To: Development Permit Panel

File: DP 16-735007

Re: Application by Alex Sartori for a Development Permit at 6020 No. 4 Road

Staff Report

SITE GRADING PLAN 1/16" = 1'-0"

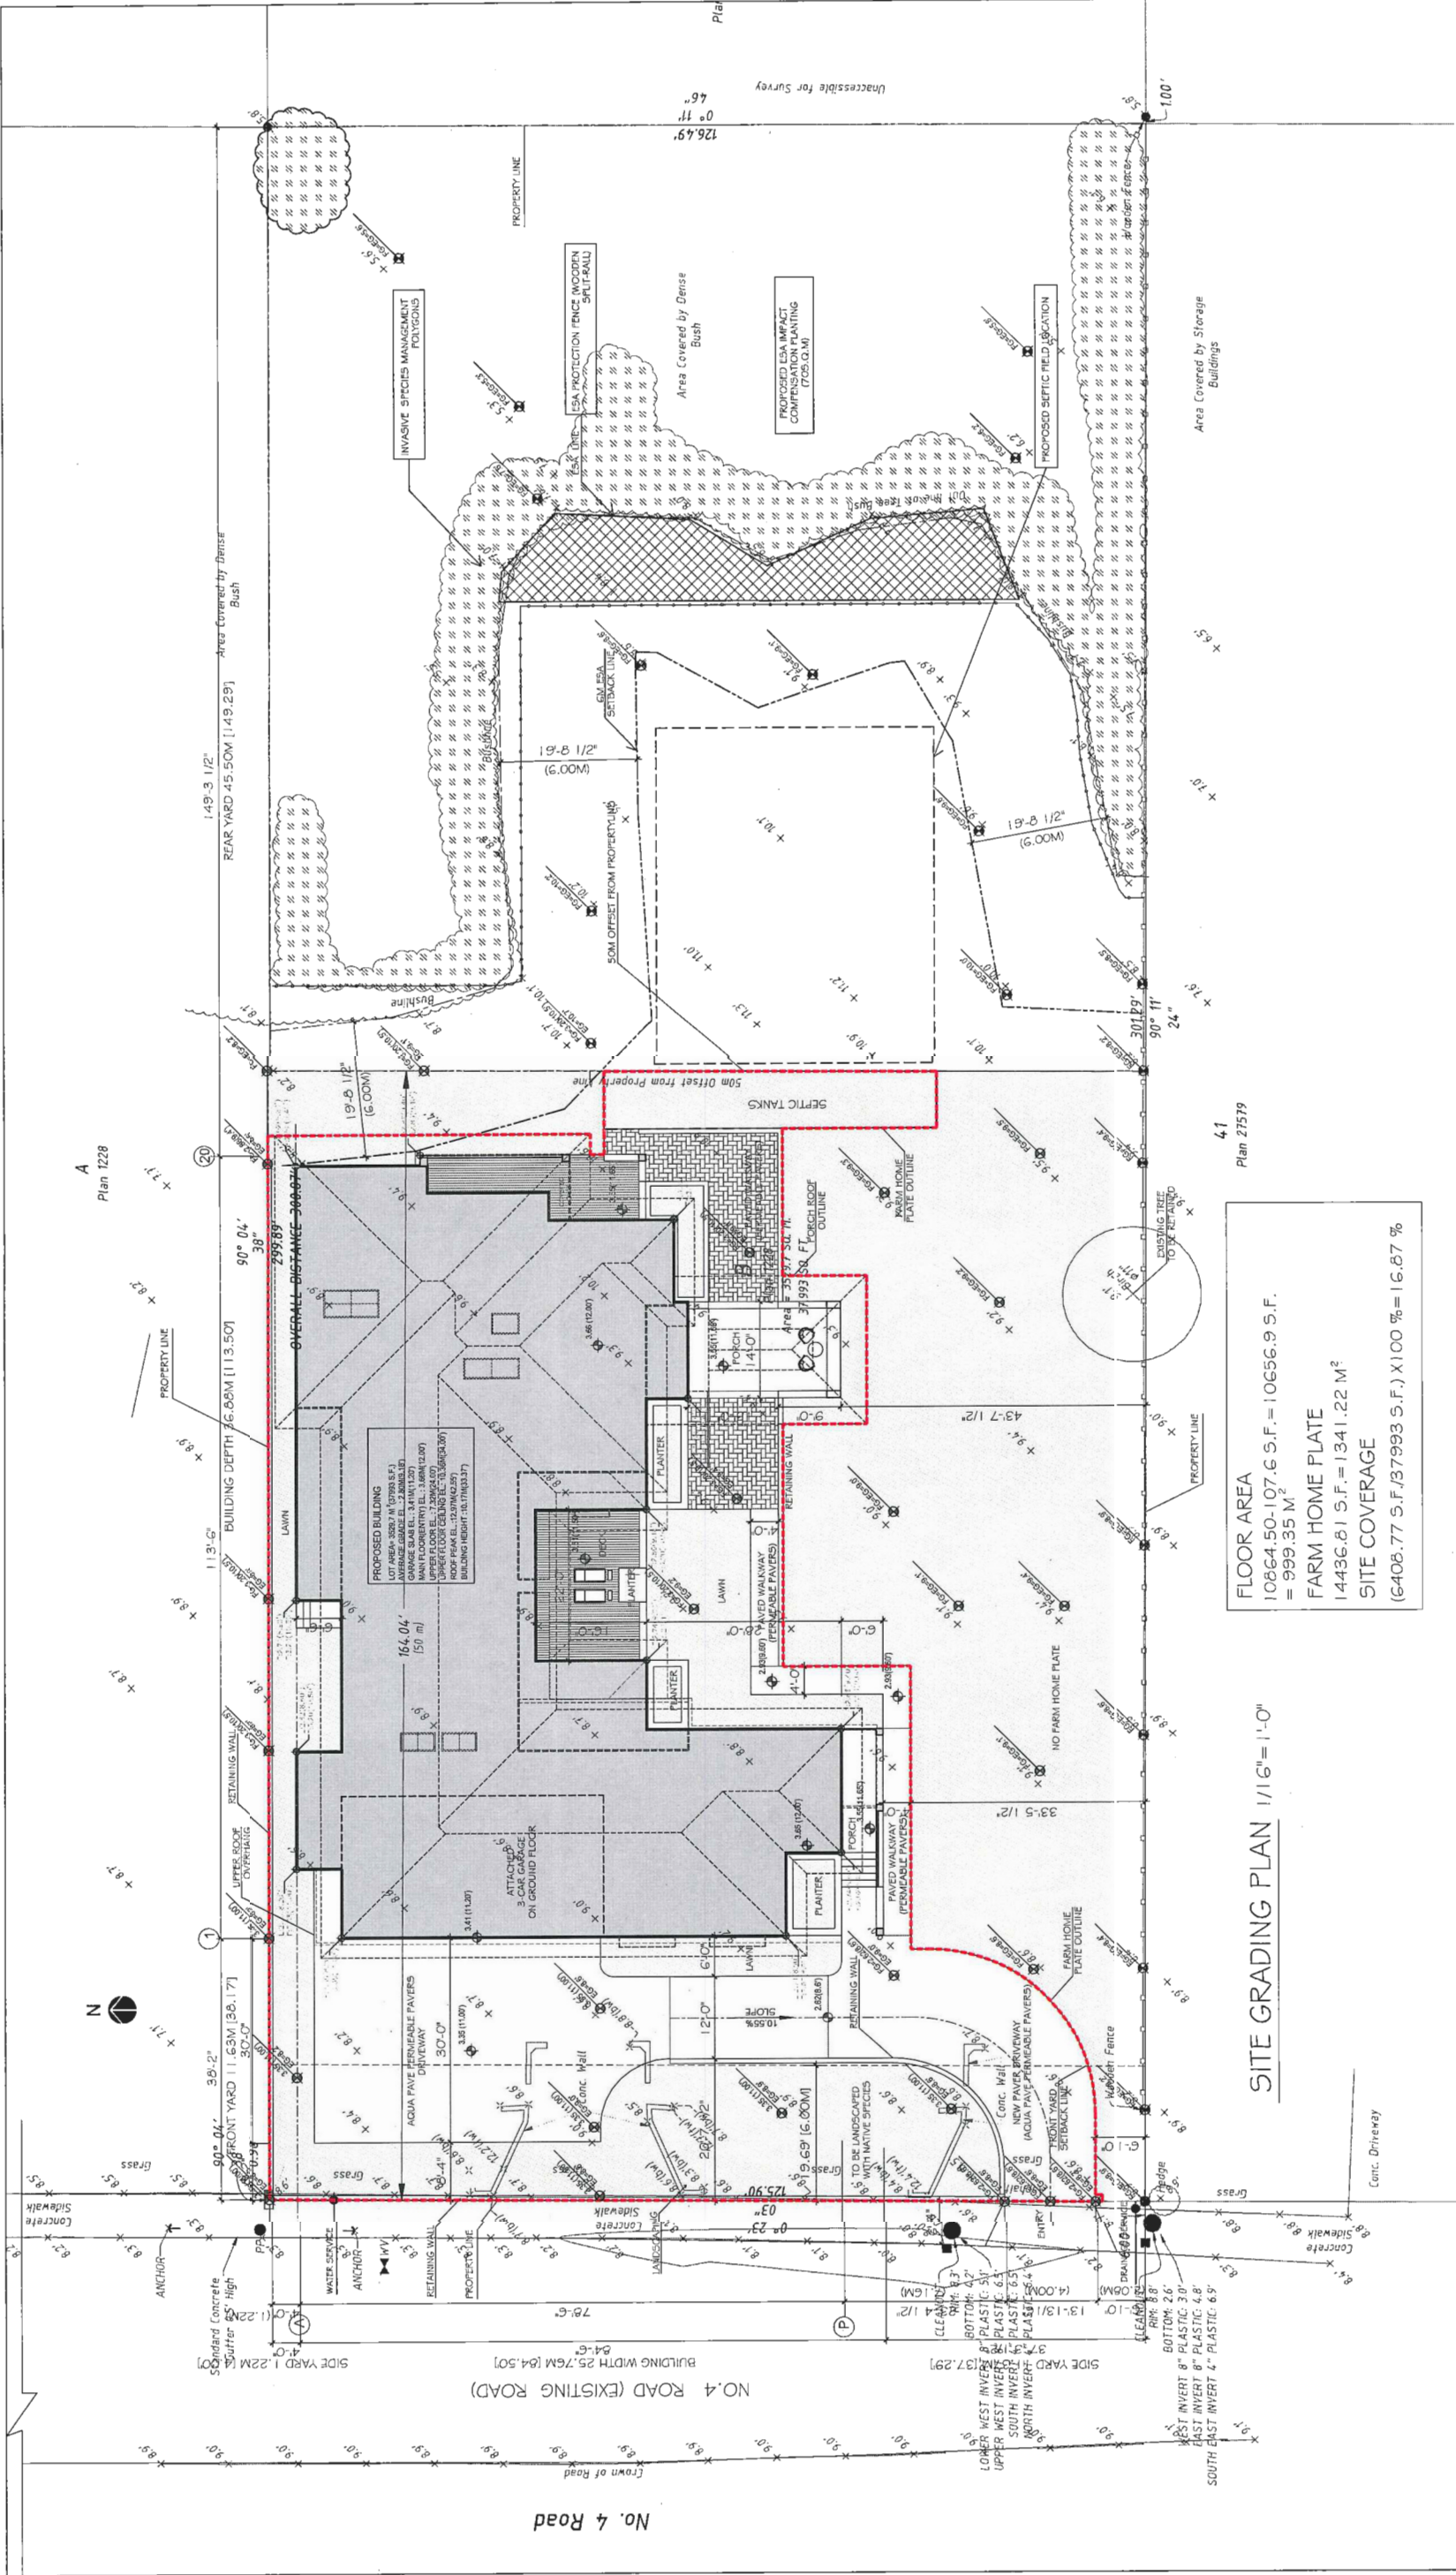
Panel Comment: ***Investigate and address potential impacts of the proposed development to neighbouring properties' drainage.***

Response: An updated grading plan has been submitted showing transitions to the adjacent properties. The grade differences are confined to the western portion of the lot with no grade changes at the rear of the property where the ESA is to be retained. Along the south side of the house the previous driveway will be replaced with native landscaping, allowing more infiltration into the soil. In addition, perimeter drainage will be required as part of the Building Permit application requirements. Perimeter drainage is required around the area being filled – in this case, at the western portion of the site where the house is proposed to be located. This combination of increased ground infiltration and perimeter drainage represent reasonable measures to address the majority of the storm run-off concerns from the site.

Sheet Name
LANDSCAPE PLAN

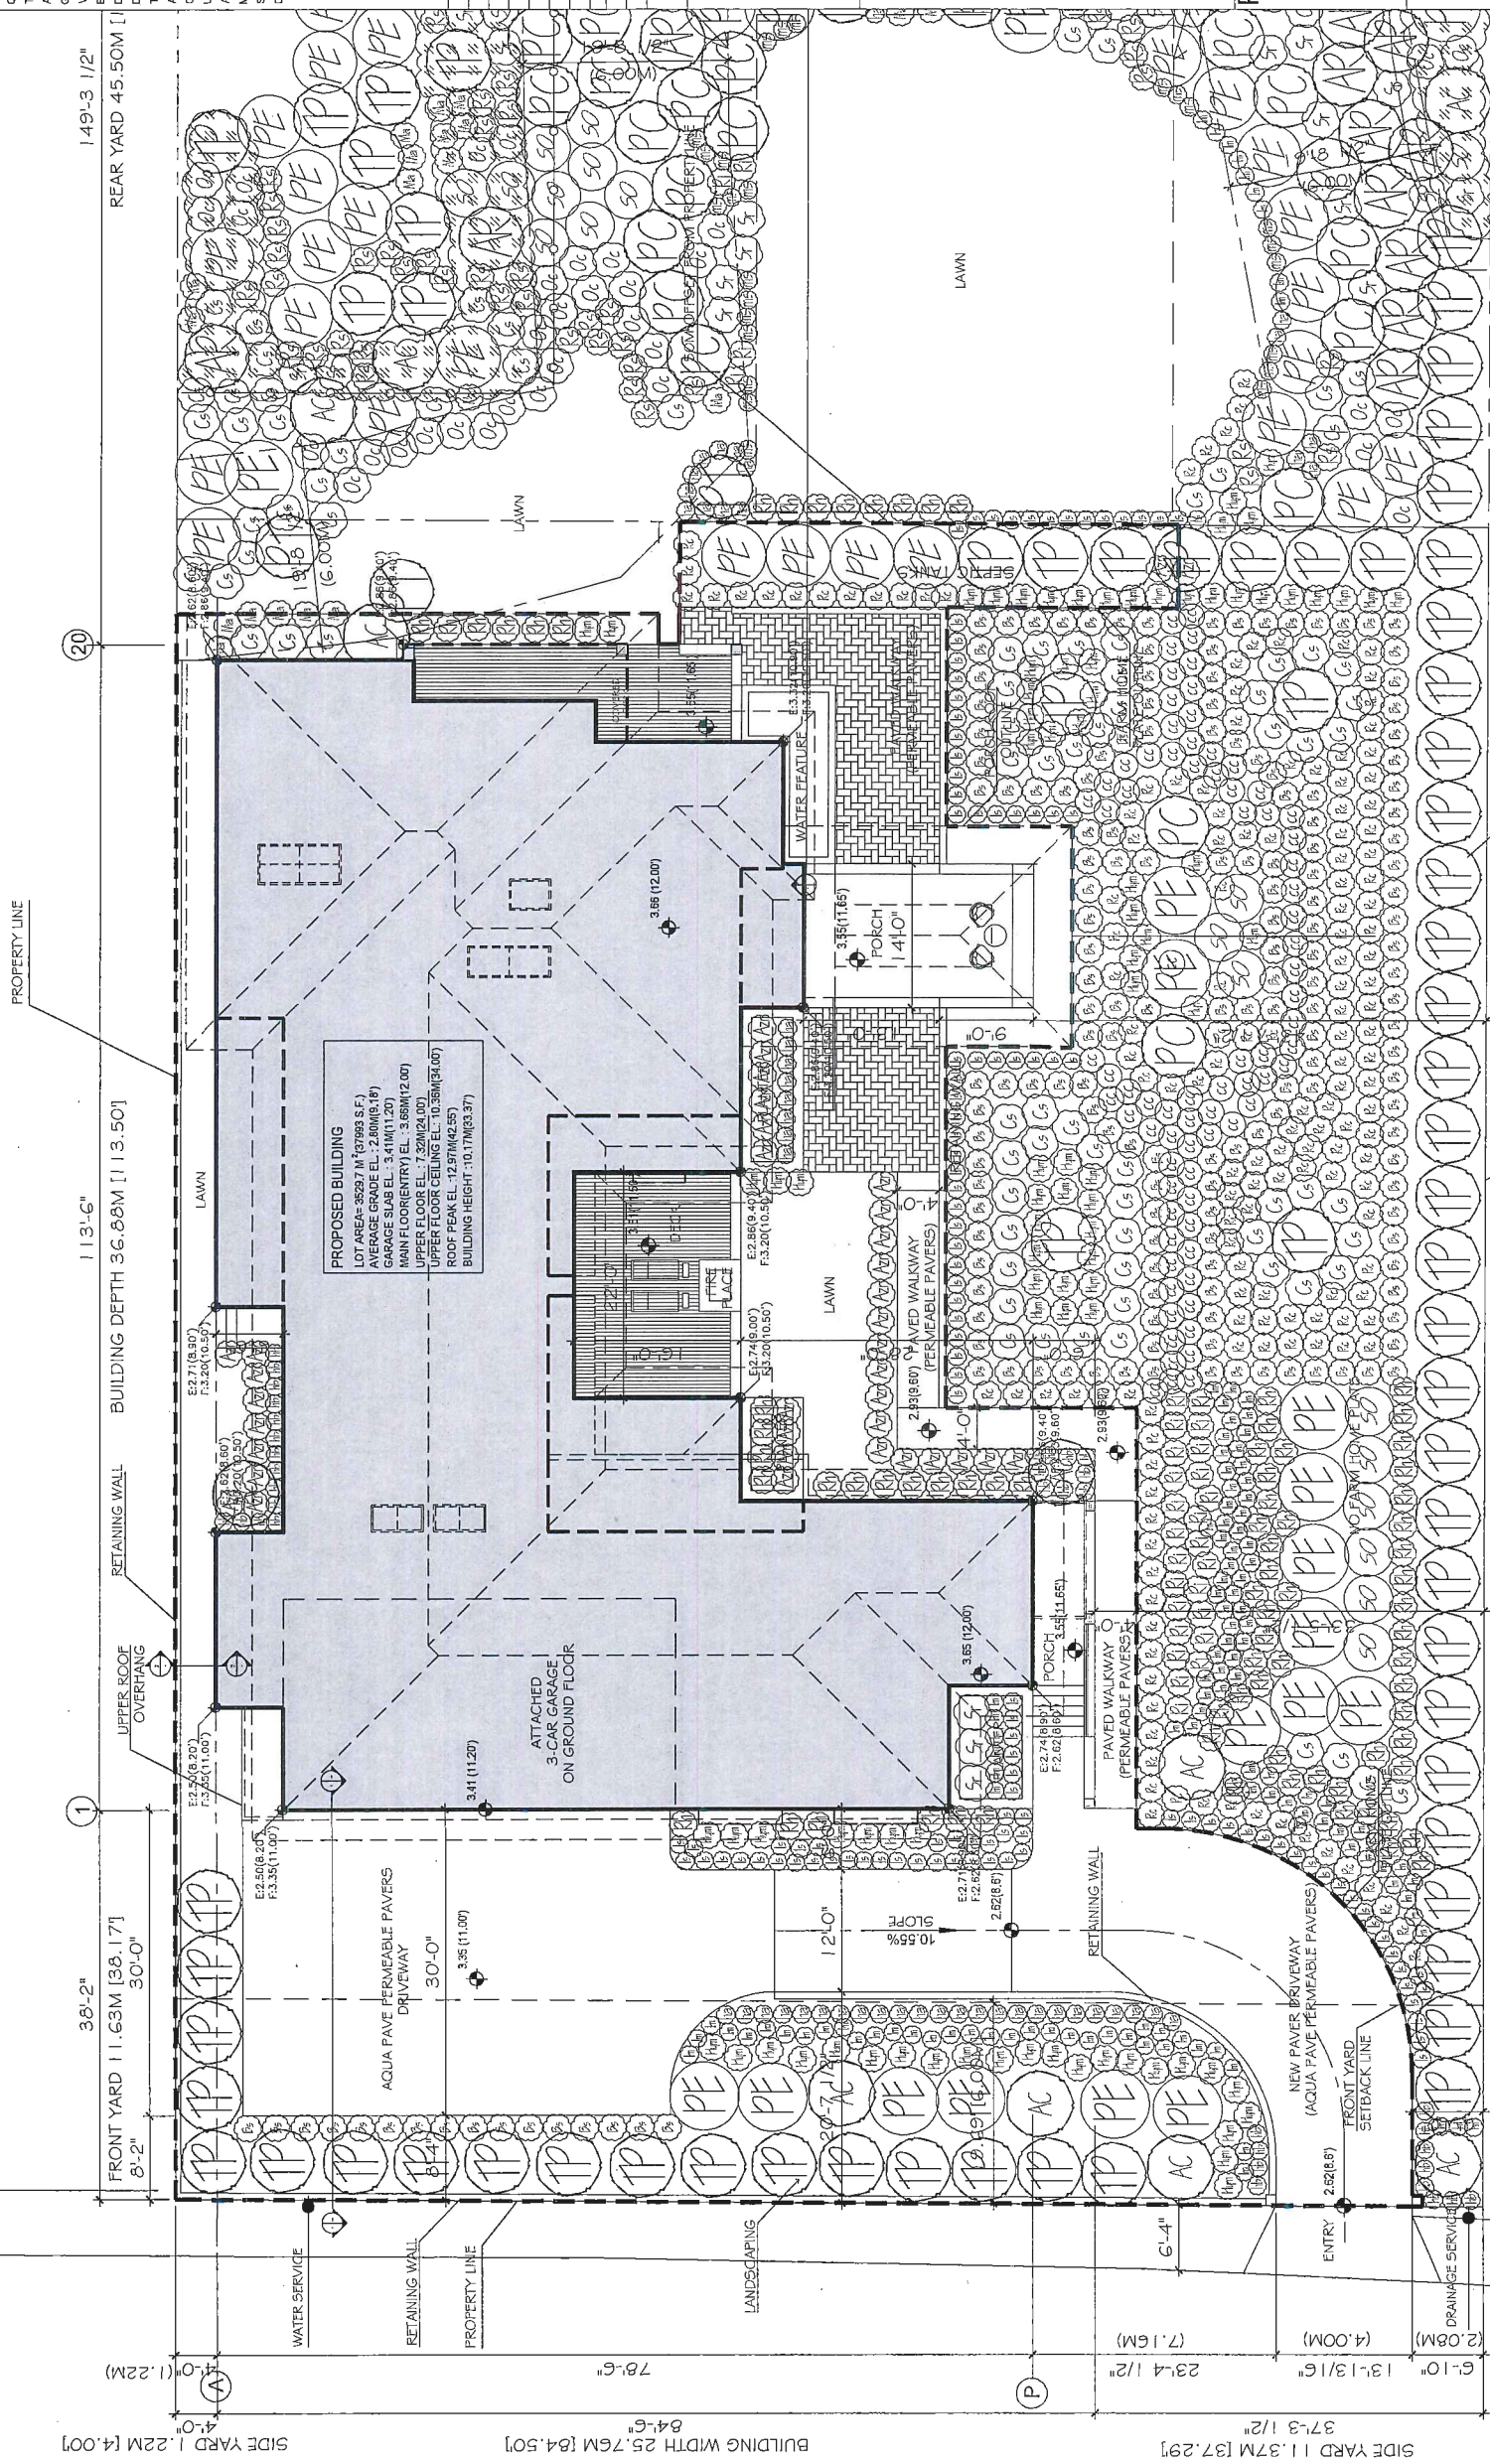
Panel Comment: *Further explain how the proposed landscaping would enhance the redefined ESA and mitigate the development's impacts to the ESA.*

Response: Three areas are proposed to be enhanced under the revised site plan:

- a. In and around the existing tree stand at the eastern end of the property, where invasive vegetation will be removed and replaced with native shrubs and trees.
- b. Across the area previously proposed for a driveway along the south side of the house, which is currently grassed with no trees and few native shrubs. The enhancement plan proposes a variety of native shrubs and trees to be installed; which will allow more opportunities for use by birds and small animals.
- c. Within part of the front yard setback adjacent to No. 4 Road.
Although this area is not included in the ESA calculations, it is proposed to be planted with a variety of native shrubs and trees replacing the largely grassed area at the front of the lot helping to increase the area of native planted landscaping.

The proposed vegetation selections are intended to diversify the habitat by broadening the vegetation types, attracting a wider range of birds and animals at the site and providing new foraging opportunities (e.g. by including shrubs with berries in the species mix). These two aspects should increase the overall value for wildlife over the existing situation.

The revised landscape plan will result in approximately 84 more trees and 356 more shrubs than the original submission overall. A total of 282 trees, 977 shrubs and 506 ground cover plants are proposed to be planted on site under the revised landscape plan.
